Construct Shoppette/Gas/NBFF/Class Six at Tyndall AFB, FL

TYNDALL AFB CONSTRUCT SHOPPETTE/ FOOD/ CLASS 6/ GAS

Sheet SUP2
Sequence of

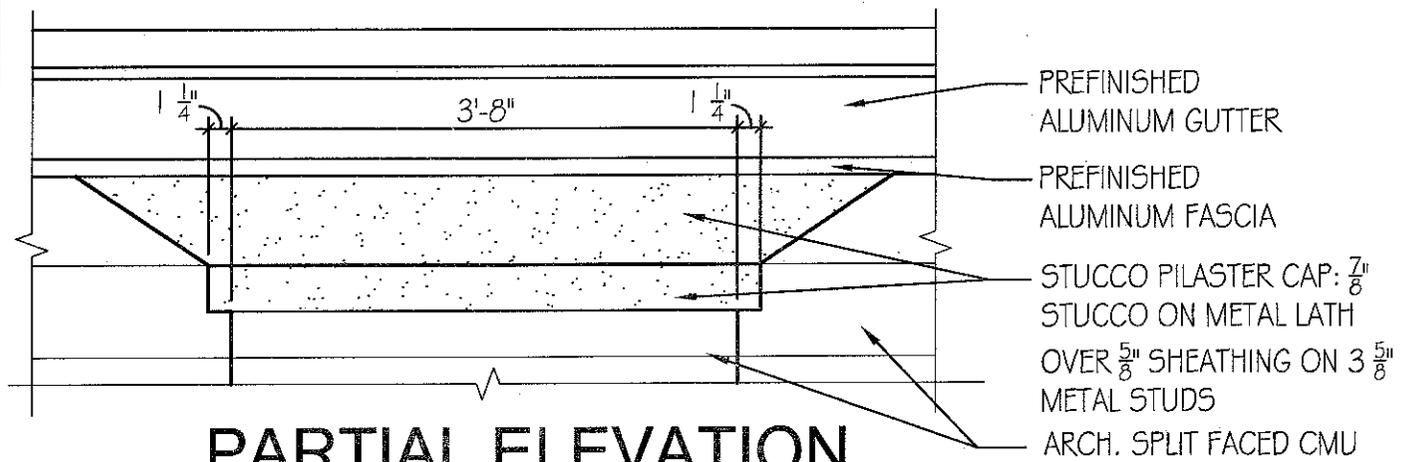
- 33.) Exterior elevations denote two different locations that have a stucco cap integral with the exterior building wall. Please provide details for same.

Answer: See Supplemental Drawings 2 & 3 (attached)

Sheet	SUP4
Sequence	of

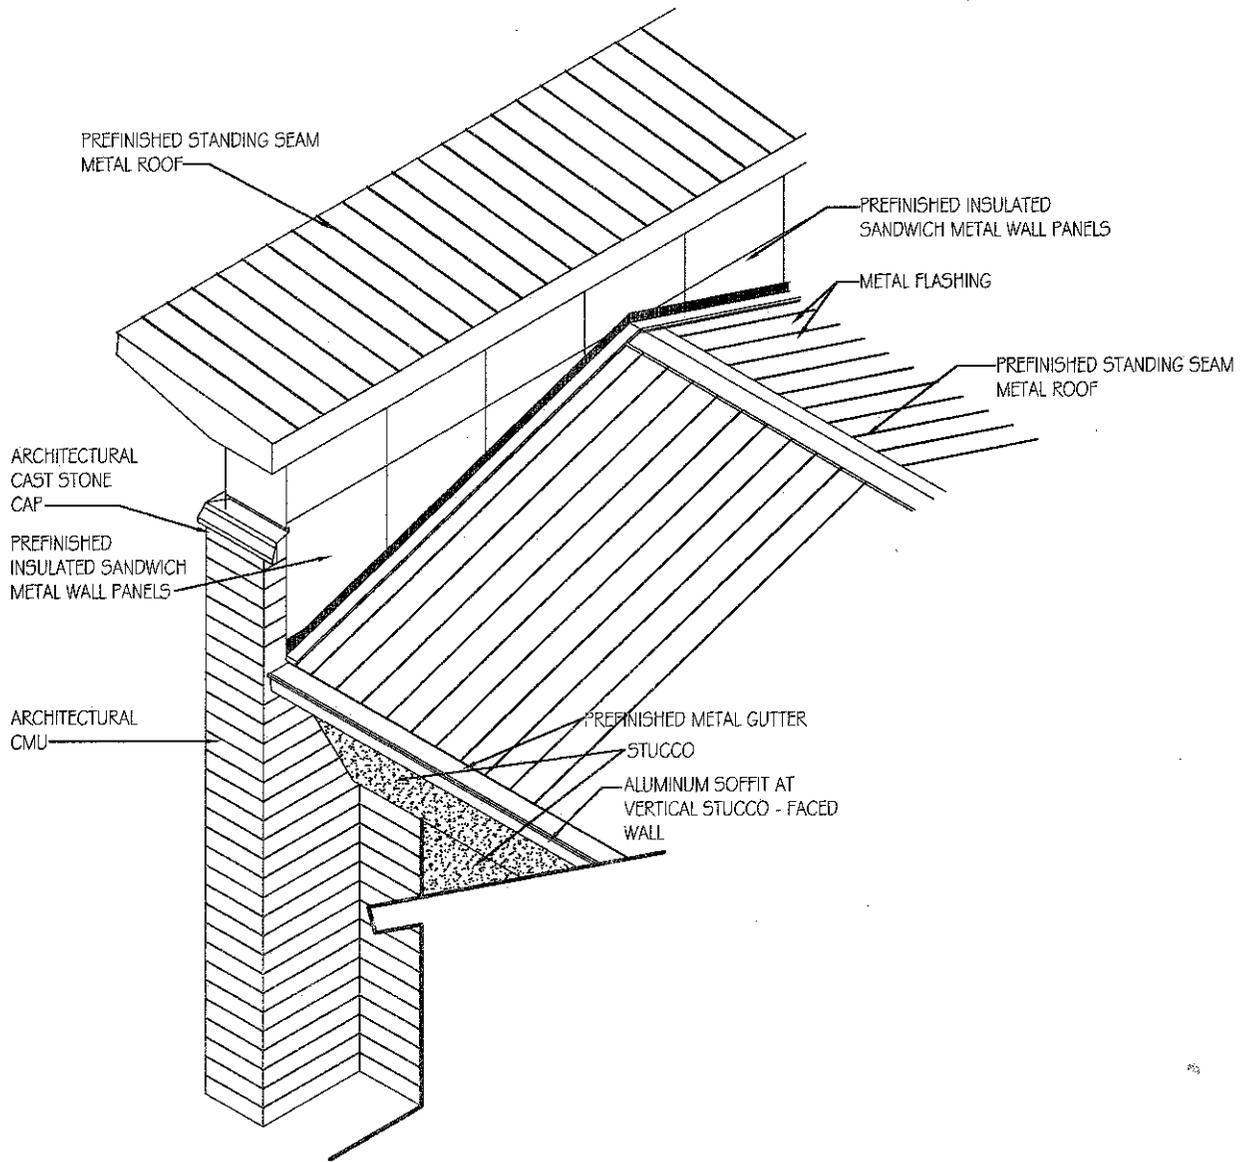
37.) The isometric detail denotes insulated sandwich panels to be used at the return soffit condition (ref. drawing A304). Is this correct or should the noted areas receive the same materials as designed for the remainder of the perimeter soffits (i.e. pre-engineered metal building components)?

Answer: Detail has changed See Supplemental Drawing 4 (attached)
